**Pipeline and Hazardous
Materials Safety
Administration**

Reference No. 16-0191

This letter is in response to your November 17, 2016, email requesting clarification of the Hazardous Materials Regulations (HMR; 49 CFR Parts 171-180) applicable to required marking(s) of the inlet/outlet(s) on MC331 cargo tank motor vehicles as it relates to a previously-issued letter of interpretation. You also provided photographs for reference.

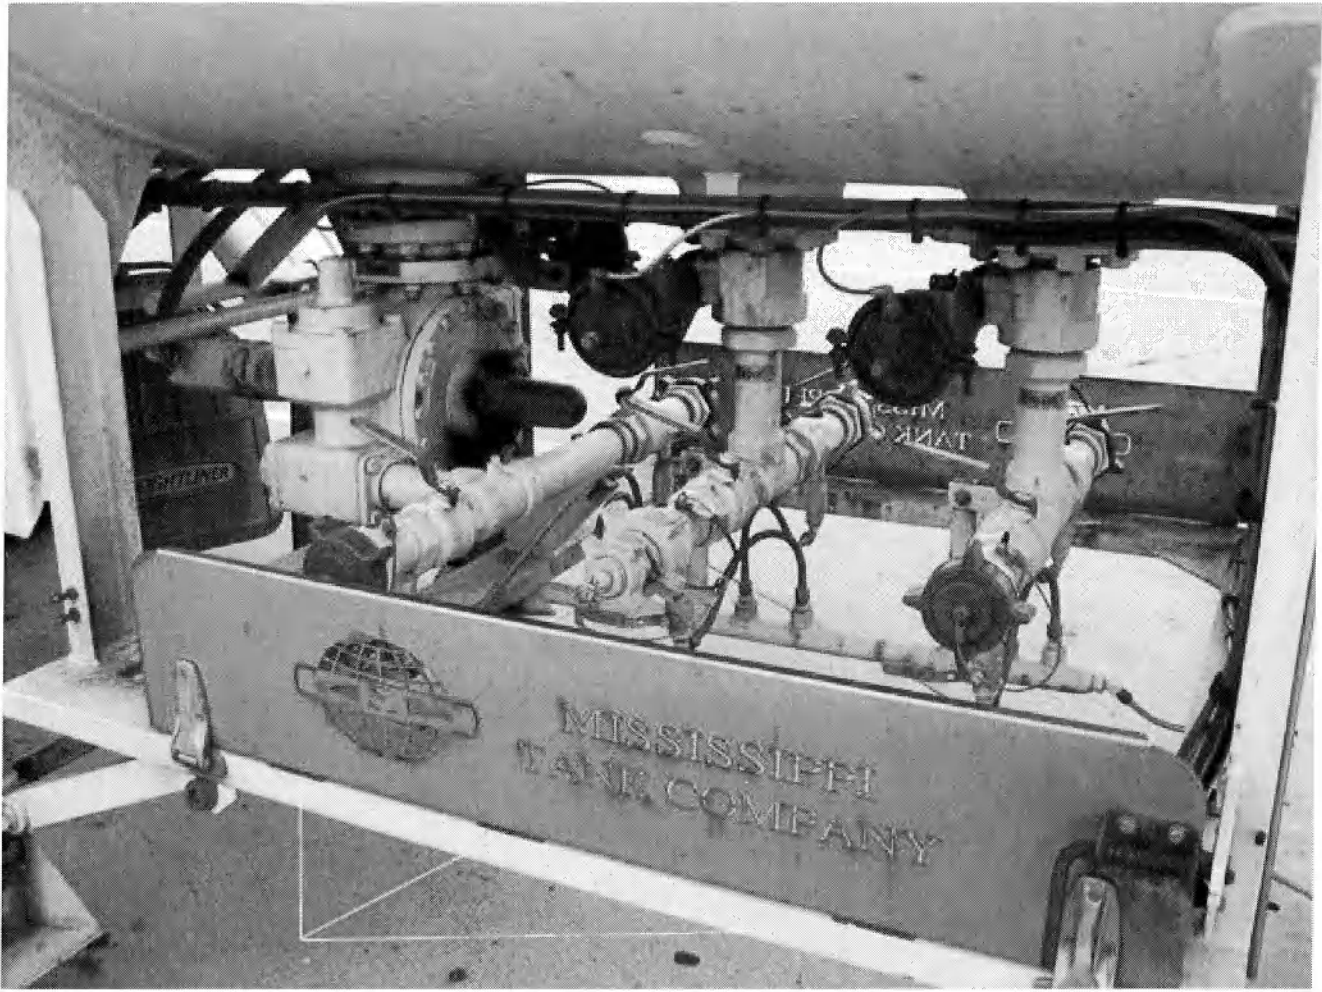
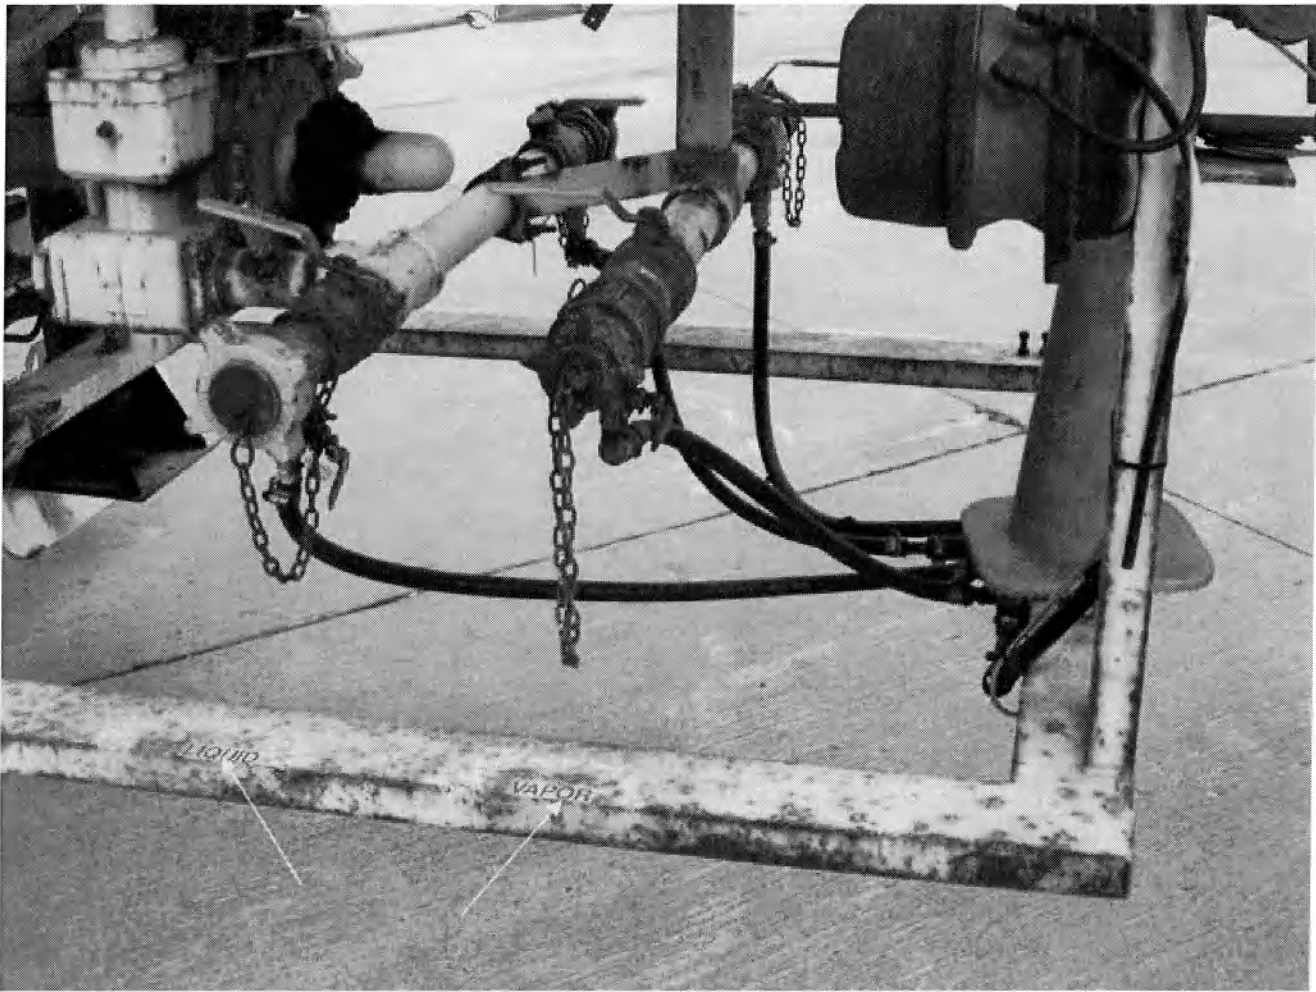
Q1. You ask whether the marking requirement in § 178.337-9(c), which requires each cargo tank inlet and outlet to be marked “liquid” or “vapor” to designate whether it communicates with liquid or vapor when the cargo tank is filled to the maximum permitted filling density, may be satisfied if the markings are placed on the accident damage protection frame.

Is the "equipment" inclusive of the accident protection required under 178.337-10? Would a cargo tank with the "Vapor", "Liquid" markings placed on the accident protection frame (see photos below), and in close proximity of the inlets/outlet make break connection be in compliance of 178.337-9(c)?

A1. The answer is yes. Provided the marking is readily visible, legible, durable to withstand transport conditions, and clearly associated with the corresponding inlet or outlet, the marking would satisfy the requirements of the HMR.
